Access Compliance Report

Public Rights-of-Way

(Curb Ramps)

Intersection ID: 49416	Main Street: CARMEL_RD	Cross Street: TUFTON_BRAE_CT	Location:	N
ADA ID: B75C3CDB29AA	Ramp Type: PerpDiag	Initial Pass/Fail: Fail	Overall Compliance: No	Severity Score: 8.75
Codes/Mitigation Info/Possible Solution		Field Measurements/Component Compliance

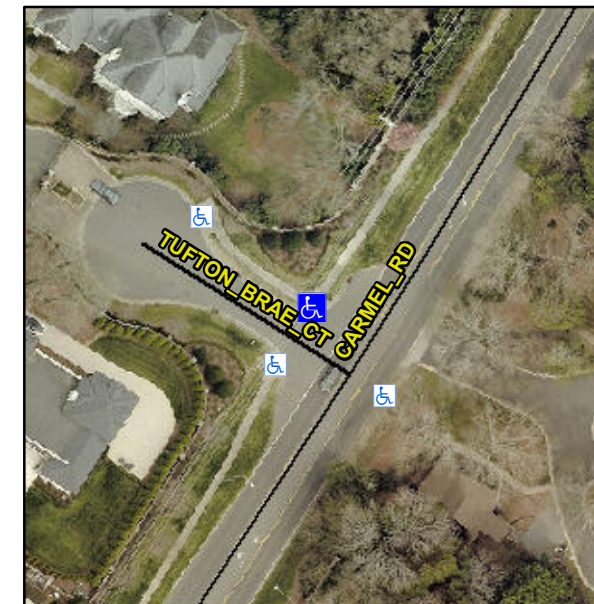
Not Found, R304.5.1

Remove & Replace Curb Ramp With Two New Directional Ramps or Equivalent.
